ORNL/NRC/LTR-03/03

ANALYSIS OF A MELCOR INPUT DECK FOR THE PEACH BOTTOM ATOMIC POWER STATION

February 2003

Figure 1. Detail of the temperature profile of the innermost radial ring for the bottommost axial level.

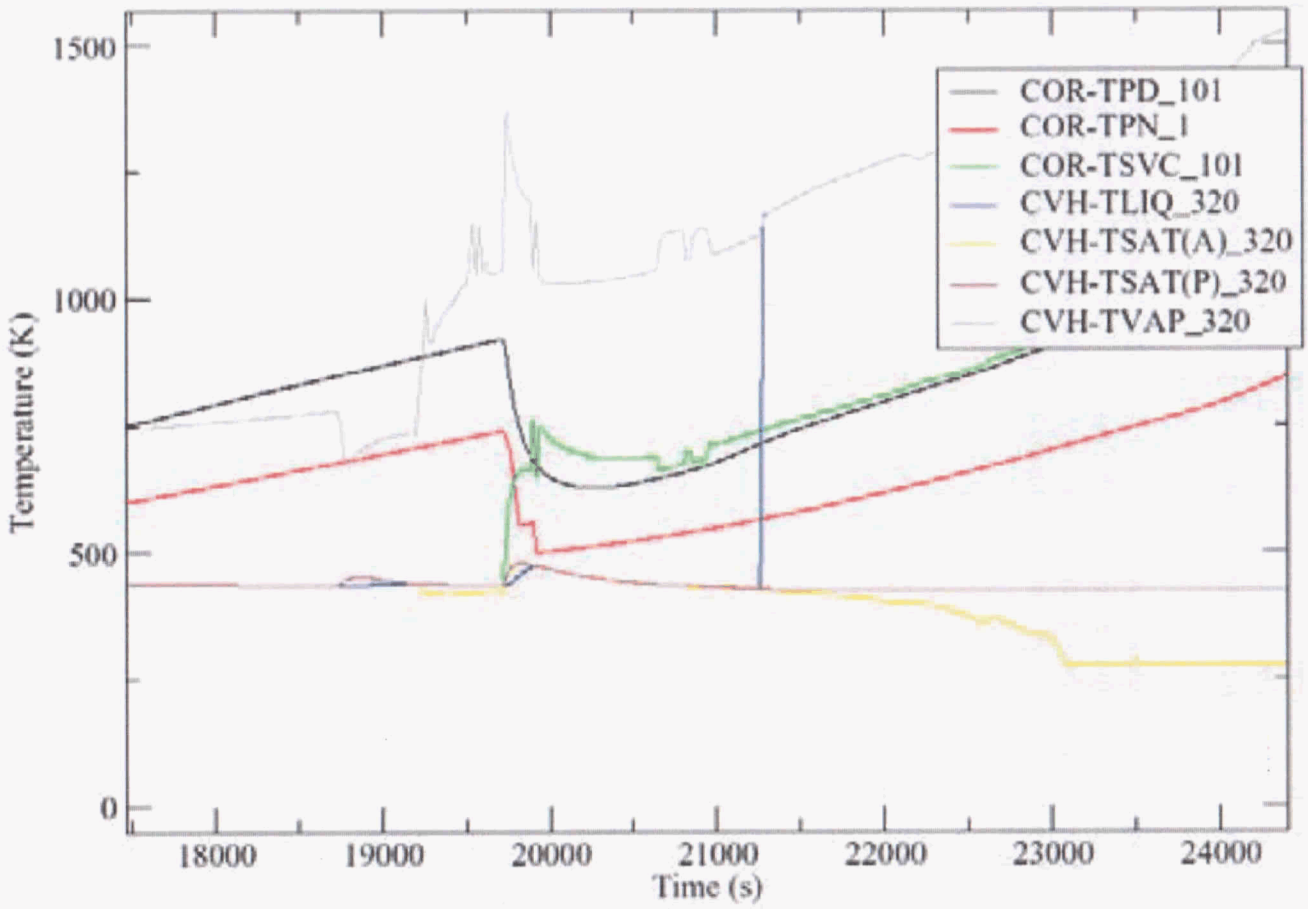
In addition to the above information, it is important to determine the point at which lower-plenum dryout occurs. From Figure 1, dryout occurs slightly after 21,000 s. In NUREG-5942, dryout was reported to occur at approximately 13,000 s. The difference between these values is most likely the result of the initial conditions, an improved core-plate model, and/or smaller radial rings. In NUREG/CR-5942, initial core-plate failure was predicted at slightly before 10,000 s, as opposed to the value given above of nearly 12,000 s. Therefore, core-plate-failure time is not that significantly different. Thus, the largest effect is most likely the reduction in relocating mass as a result of the smaller radial rings.

Figure 2. Temperature profile of lower-head penetrations and two innermost lower head nodes.

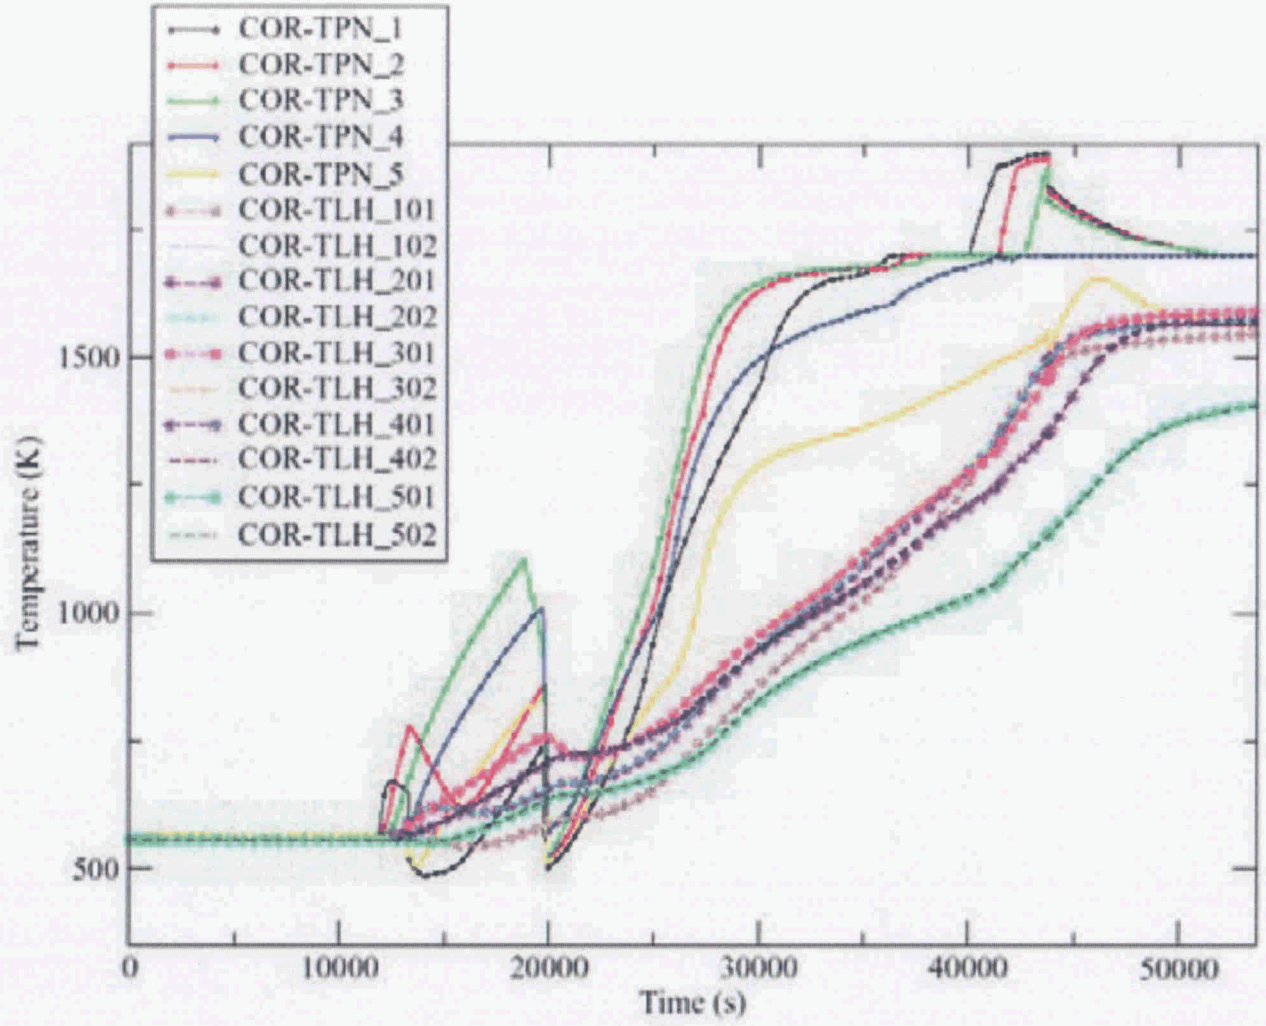
Figure 2 shows the temperature profile of the penetrations and the innermost regions of the lower head. As can be seen from the figure, the penetrations heat up gradually after core-plate failure until around 20,000 s when a sharp drop in temperature occurs. Figure 3 provides a greater detail of this drop for the innermost radial ring. The apparent cause of this temperature drop will be discussed later.

Figure 3. Comparison of penetration temperature in the inner radial ring as the water level drops.

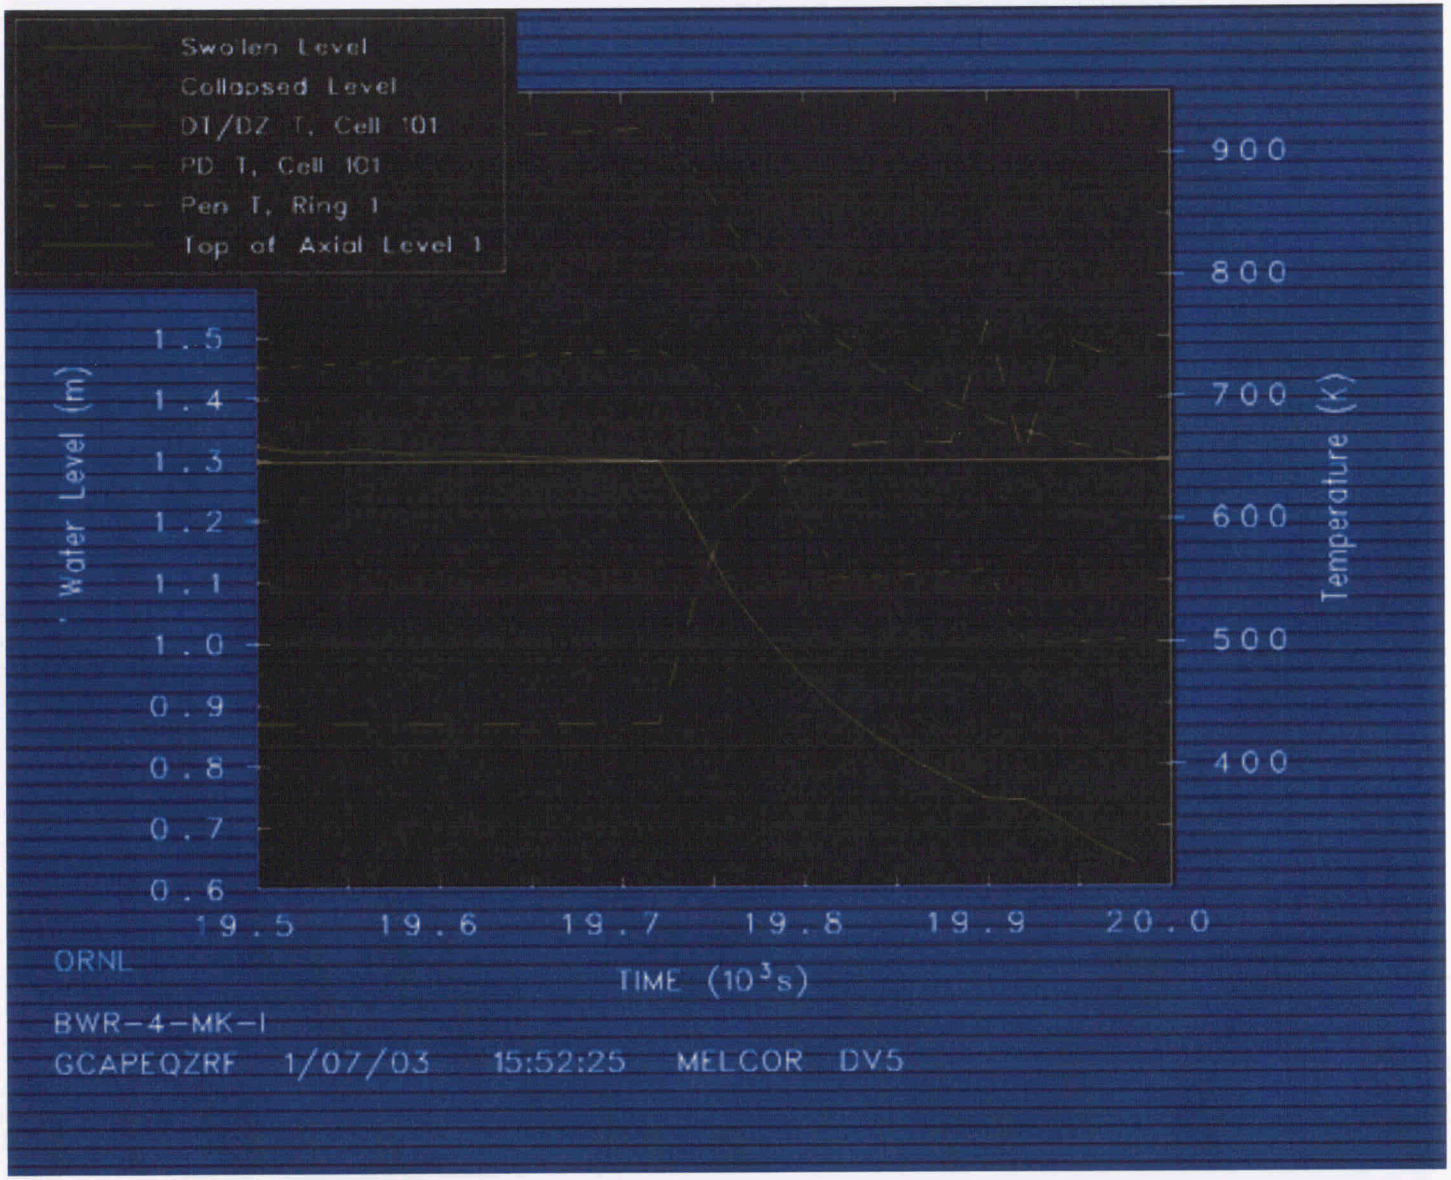
Thus, it is apparent that mass ejection from the vessel is dependent on the failure mechanism of the penetrations alone. Because of this dependence, a thorough examination of the heat-up of the penetrations was performed. During this examination, a discontinuity in the temperature profile of the penetrations was discovered, as noted above and shown in Figure 3. The problem appeared to occur during lower-plenum dryout. When the swollen water level drops to the top of the first axial level, as seen in Figure 3, the temperature of the penetrations drops nearly 500 degrees. This inconsistency is

probably related to a change in the models associated with the regime change, i.e., in going from water covered to a mixture of both air and water.

Figure 4. Mass ejection from the lower plenum to the drywell.

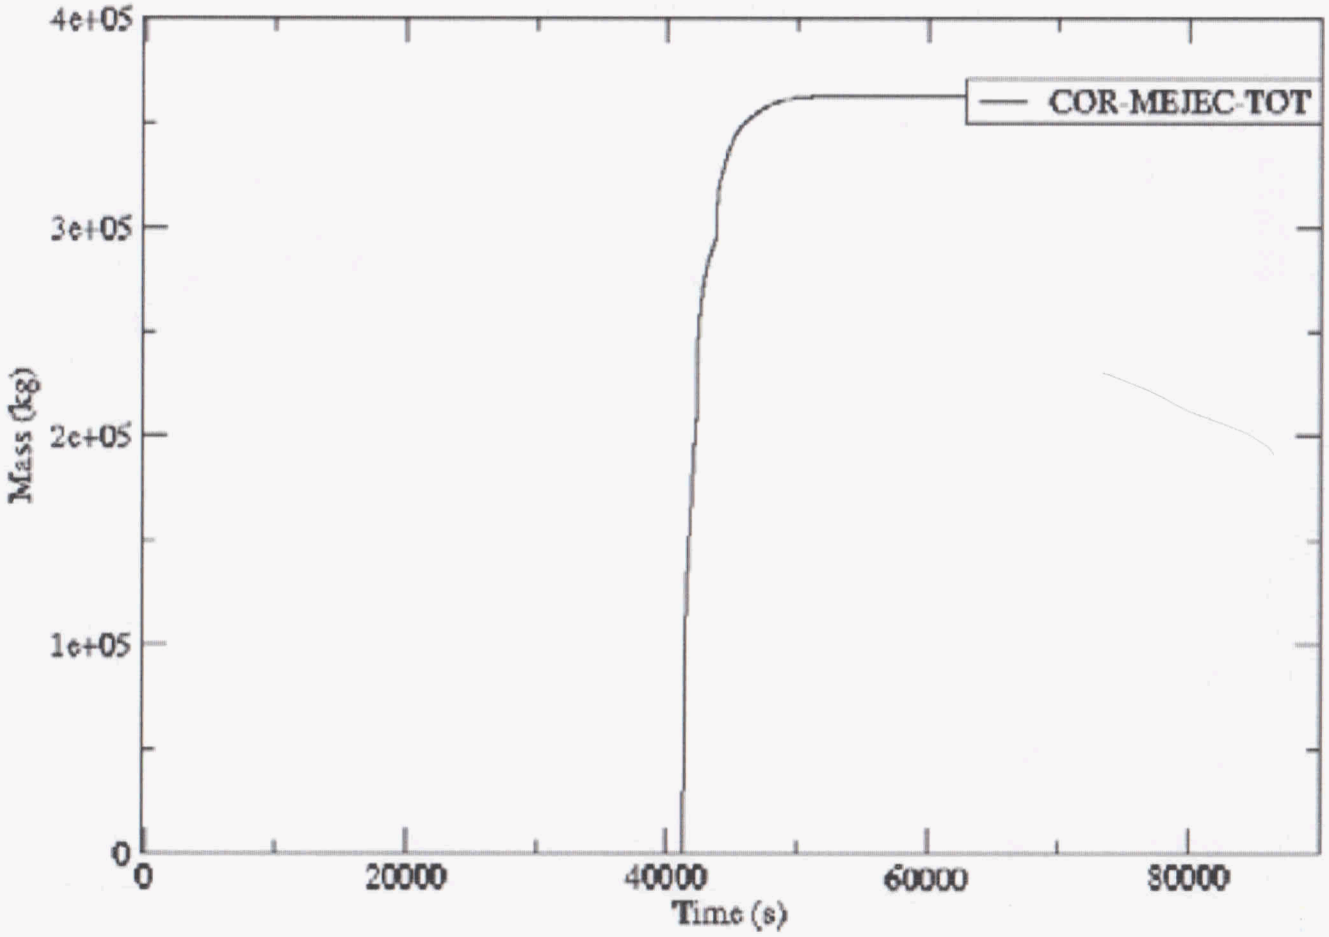
Because of this temperature drop, melt ejection is delayed until after 41,000 s, as seen in Figure 4. Again from NUREG/CR-5942, melt ejection was previously determined to occur at slightly after 16,000 s. Examining Figure 5, which shows the debris-bed temperatures starting at 25,000 s, the debris-bed temperatures are in excess of the temperature required to fail the interstitial stainless-steel guide tubes. Therefore, melt ejection should have occurred significantly earlier than predicted; this is the first inconsistency.

Because of the late melt ejection, a large portion of the debris is liquid or extremely hot. This leads to the second questionable result: the speed that material is ejected through the penetration. Starting at 41,303 s (the first penetration failure) to 42,234 s (second penetration failure), material is ejected at a very large rate, nearly 210,000 kg of material is ejected (over half of the total ejected mass) or an average rate of 226 kg/s. As stated, this is a direct result of the delay in failure of the penetrations and the buildup of molten material within the debris bed. Because of this large melt ejection, the vessel itself never fails, and all material exits through the penetrations.
